Second Revised Pre-Hearing Statement of Advisory Neighborhood Commission 6C

District of Columbia Board of Zoning Adjustment Appeal No. 19550

Advisory Neighborhood Commission 6C (“ANC 6C”) submits this second revised pre-hearing statement¹ in support of its appeal from the issuance of permit B1805207 (“the Revised Permit”). For the reasons set forth below, we respectfully urge the Board to order the revocation of the Revised Permit.

Detail from Sheet A5.2 (Tab B)

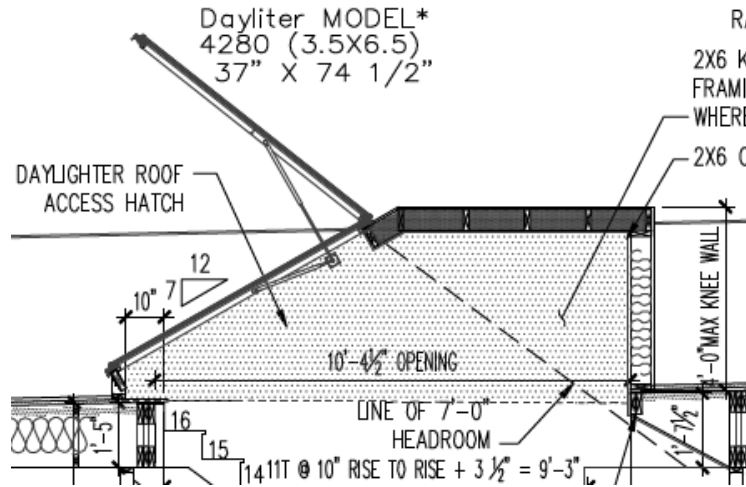
Sheet A5.2 of the approved drawings (Tab B) for the Revised Permit nevertheless shows two penthouses: one on the front structure and one on the rear.

In addition to violating section 1500.4, the proposed penthouses are inconsistent with two other provisions of section 1500. First, the enclosing walls of penthouses must be of “equal, uniform height” except for those enclosing habitable space or elevator overrides. *See* § 1500.9. As seen clearly on sheet A5.2, the walls enclosing the penthouses here are not of uniform height.

Second, because these penthouses are—as discussed above—not “in accordance with the conditions specified” in section 1500 overall, § 1500.1, they are not exempted from the height restriction of the applicable zone. As seen on sheet A5.2, the proposed building is 34’ 11” tall as measured to the top of the roof, and both penthouses project well above the 35’ height limit for the RF-1 zone. *See* 11 DCMR E § 303.1.

Detail from Sheet A3.1 (Tab B)

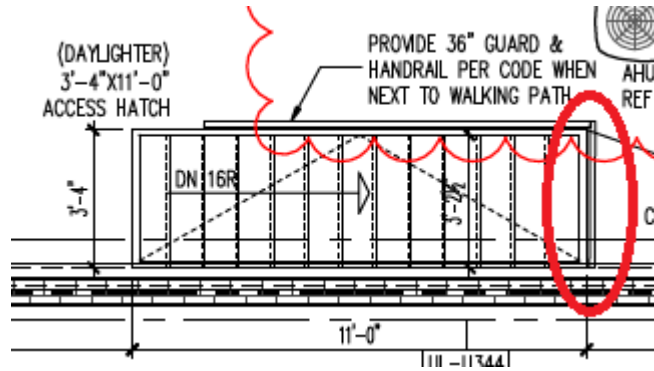
Sheet A3.1 shows the penthouses directly abutting the north side building wall. See Tab B. The configuration shown on sheet A5.2—with 4’ tall stair enclosures—plainly lacks the required 1:1 setback. *Id.*

We note that the Revised Permit drawings at Tab B contain conflicting information about the stair access to the roof. Sheets A3.1 (roof plan) and A5.1 (section) do not show the 4’ stair enclosures, but instead irreconcilably depict a low hatch, perhaps 1.5’ tall, hinged on one edge.

These inexplicable conflicts in the drawings, while troubling, make no difference here. Sheets A3.1 and A5.1 show a 36” tall guard rail subject to the same setback requirements. A portion of that guard rail directly abuts the north side building wall and therefore violates section C 1502.1(c). So does the hatch itself.

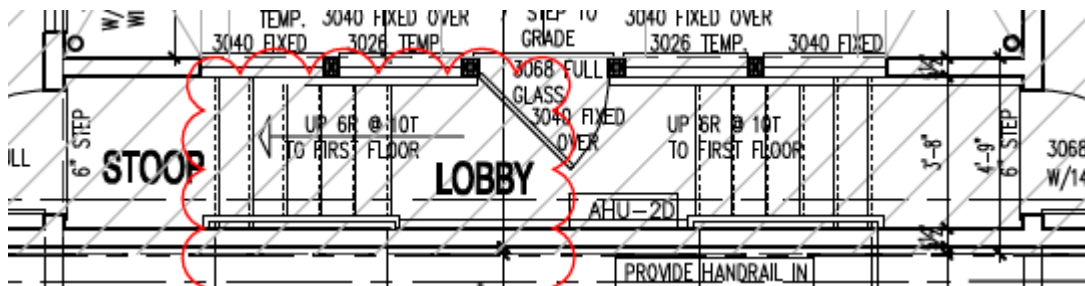
Sheet A1.1 of the Revised Permit drawings (at Tab B) shows the so-called “lobby”:

Self-evidently, this narrow (3’8”) connecting corridor is not a lobby, recreation room, or other qualifying area. It serves not as a “common space” intended for shared functional use, but instead strictly as a means of passage⁷ between different portions of the Property, and thus it fails to satisfy the first alternative prong of subsection (d).

Subsection (d)(2) is equally unavailing. That test requires a qualifying connector to provide “free and unrestricted passage between separate portions of the building, such as an unrestricted doorway or walkway.” But as the first-floor plan (sheet A1.1 at Tab B) shows, the corridor starts at the rear door—obviously locked—of Unit #1’s kitchen and ends at the entrance—also obviously locked—of Unit #2’s living room.

Detail from Sheet SP.01 (Tab B)

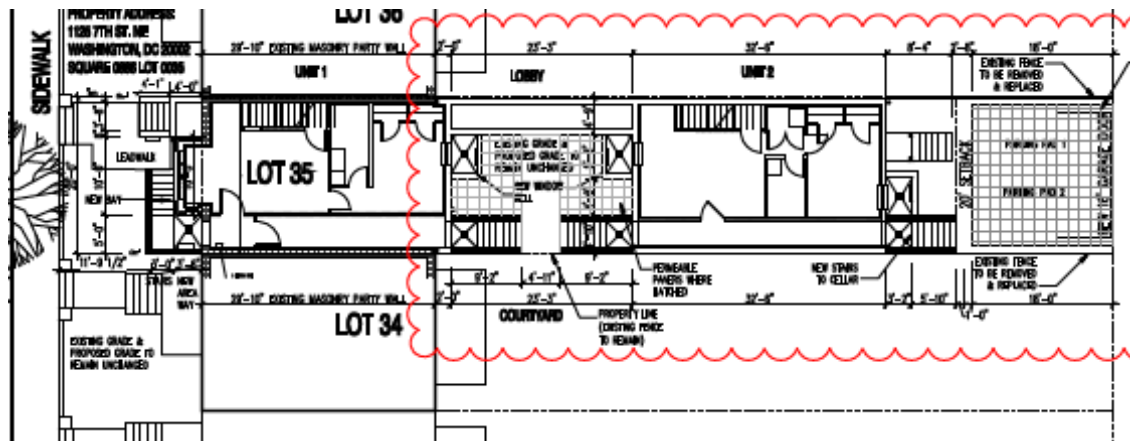
As shown on drawings A1.1, A4.2, and SP.01 (*see* Tab B), the Revised Permit authorizes the construction of a rear addition at the Property extending 57'9" past the rear wall of the adjoining principal residential building at 1123 7th St. NE.

Unit #1 Third-Floor Plan (Detail, Original Permit drawing A2.1, Tab D)

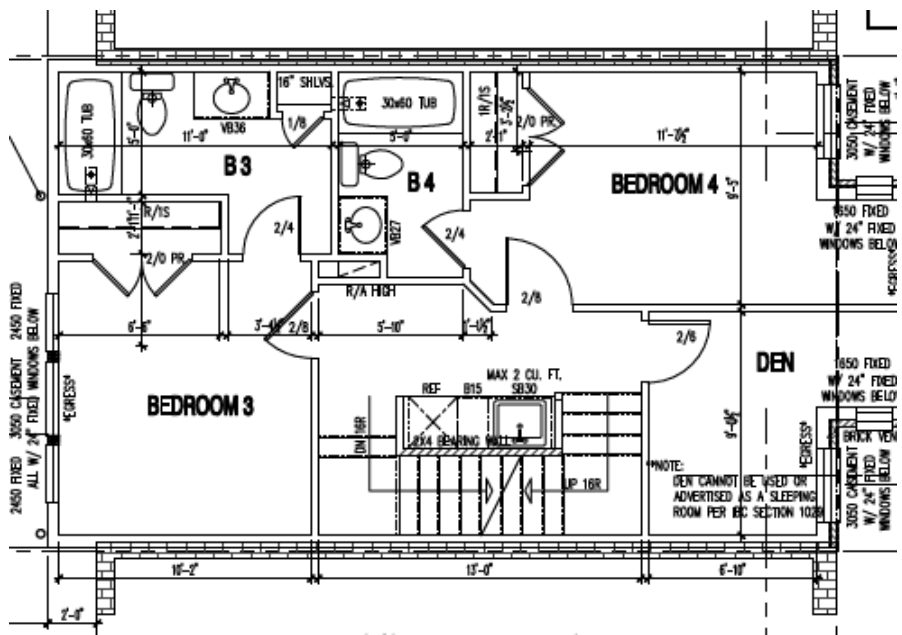
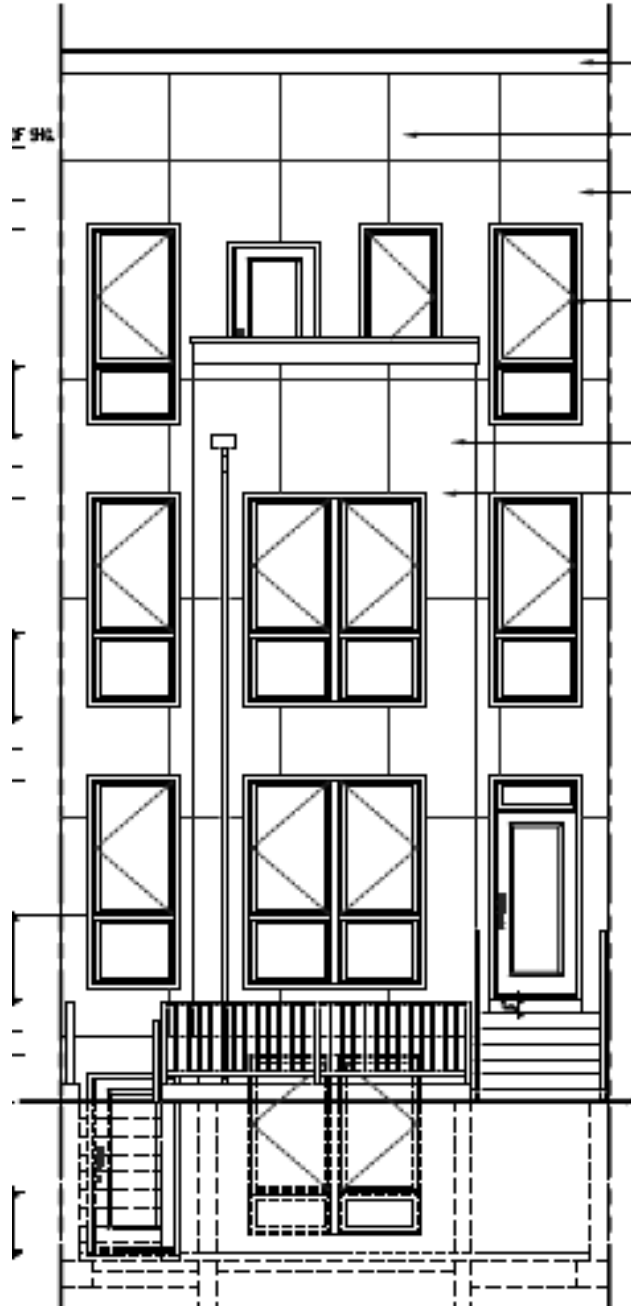
The Revised Permit flips the proposed internal configuration of every level in the front building, as illustrated in the sample detail below.

Front Elevation (Detail, Original Permit Drawing A4.1, Tab D)

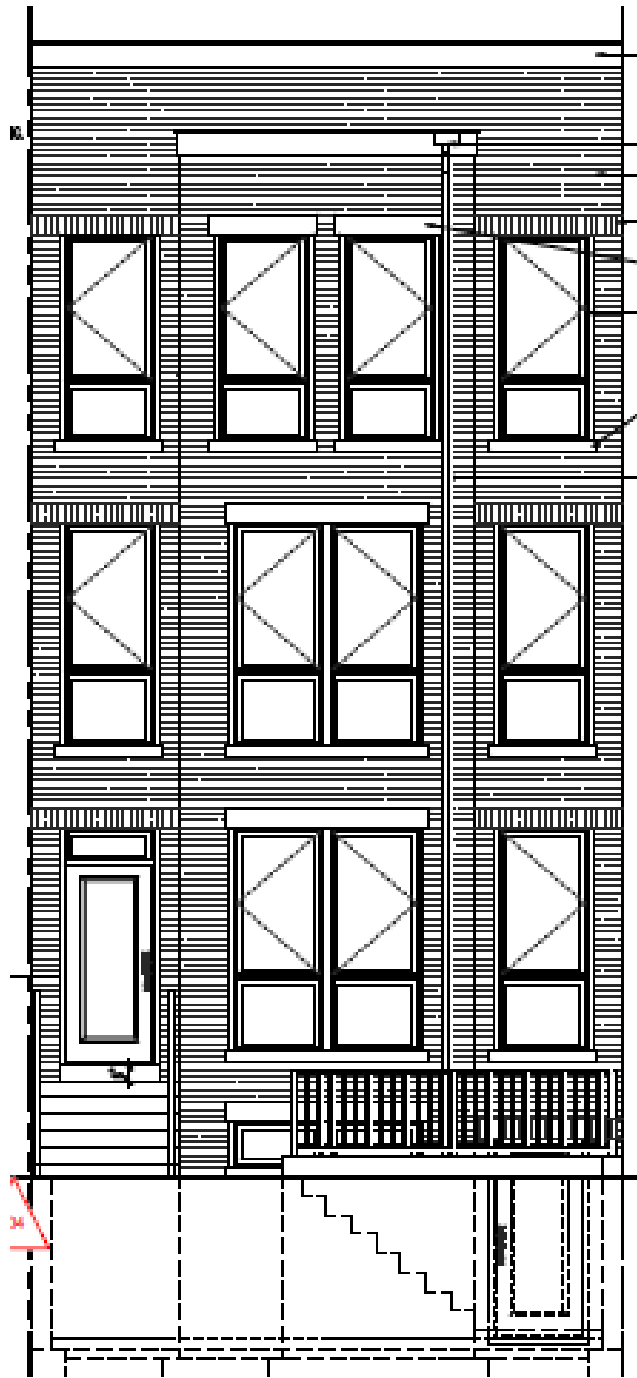
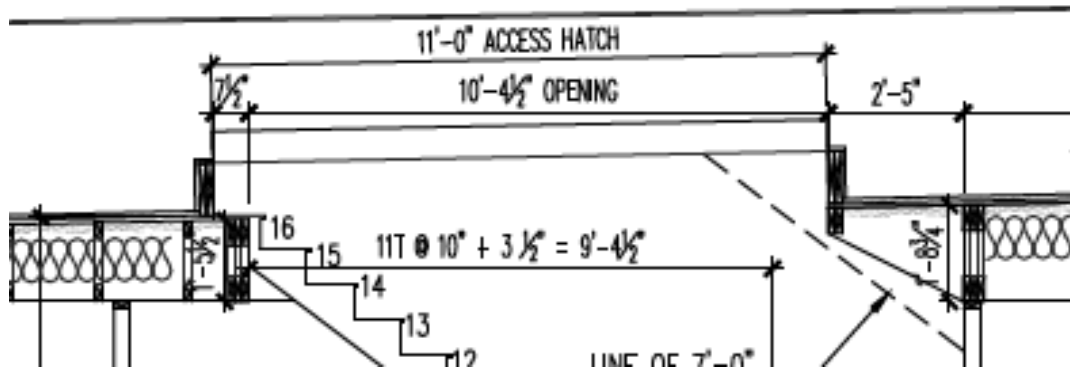
The Revised Permit radically alters the proposed front façade, indicating entirely different materials, increasing the projecting bay height from two stories to three, and flipping the front entrances to opposite sides.

Rear Structure Roof Section (Detail, Original Permit Drawing A5.2, Tab D)

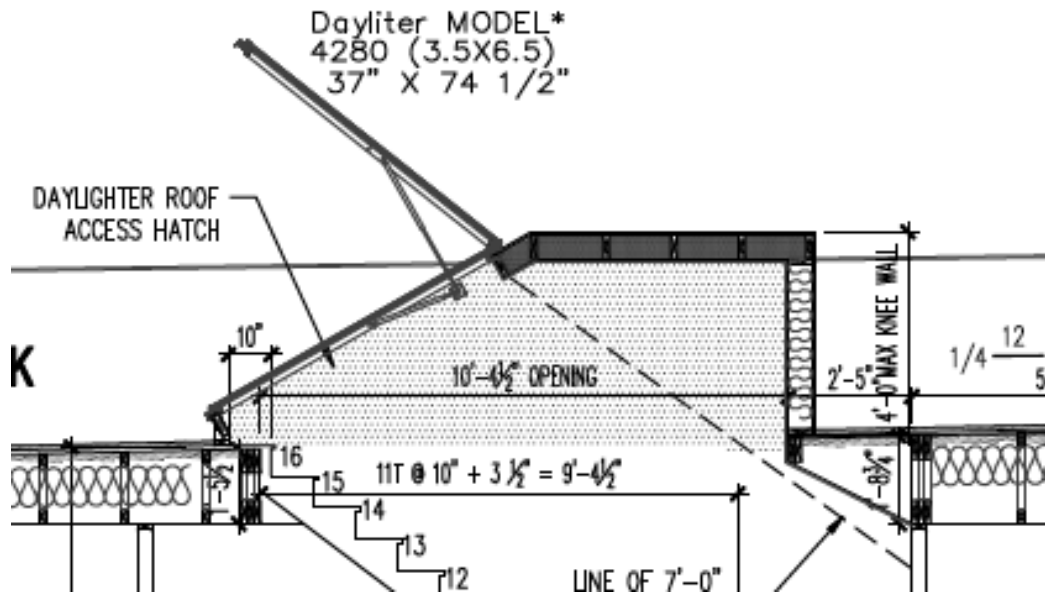
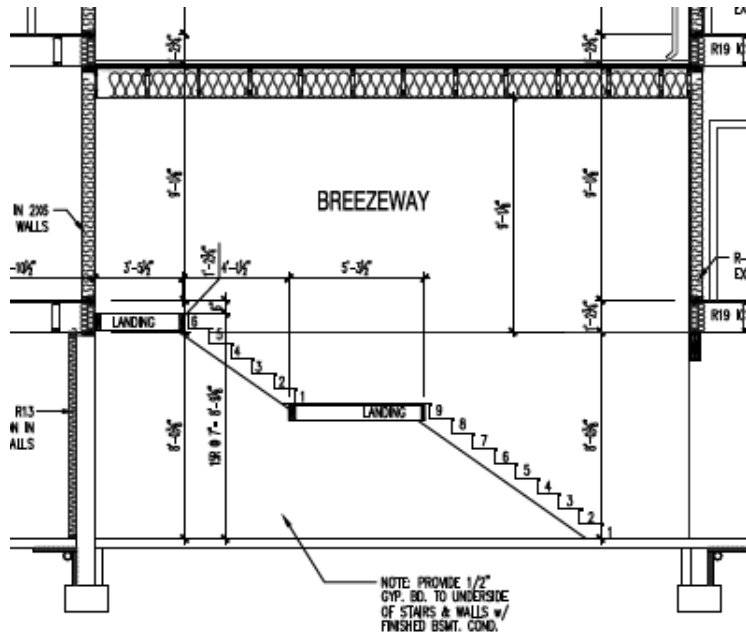
The Revised Permit shows a markedly different set of proposed roof structures (discussed above in Parts A and B).

“Breezeway” Section (Detail, Original Permit Drawing A5.2, Tab D)

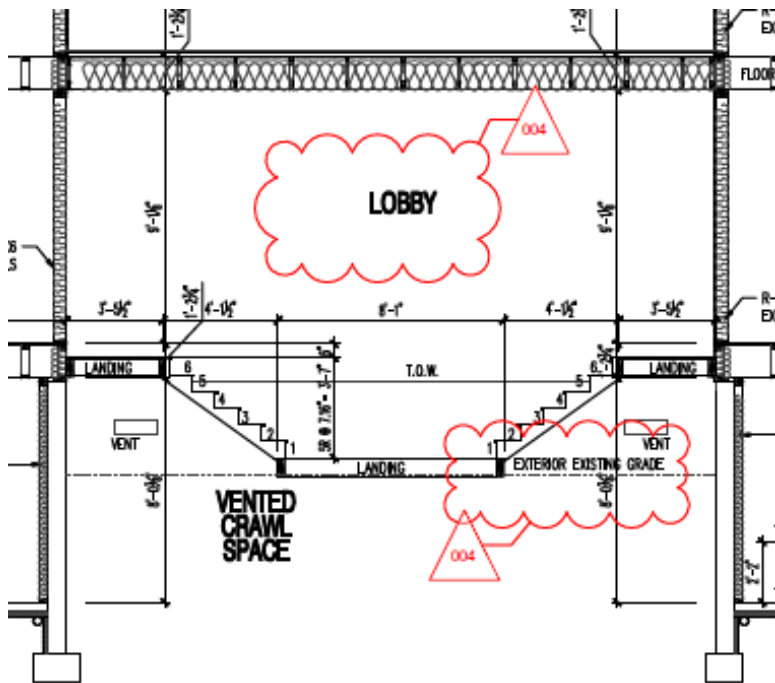
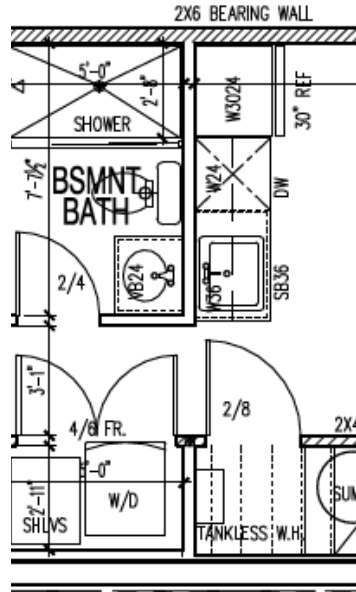
The Revised Permit significantly alters the proposed “breezeway” to bring it above grade, obviously responding to the zoning defect noted in ANC 6C’s initial appeal and previous pre-hearing statements.

Rear Structure Cellar Plan (Detail, Original Permit Drawing A1.1, Tab D)

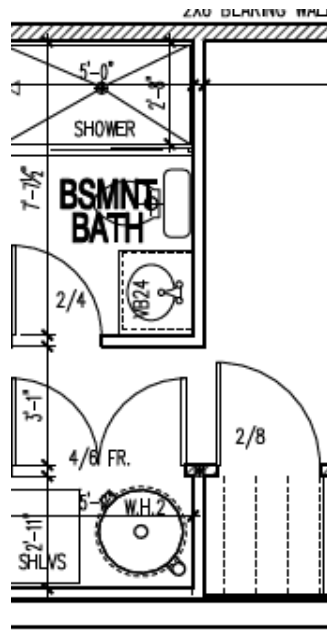
The Revised Permit removes the proposed separate kitchen facilities in both the front and rear cellars, once again responding to the valid objection in this appeal's initial filing that the Original Permit allowed two illegal units beyond the maximum.⁸
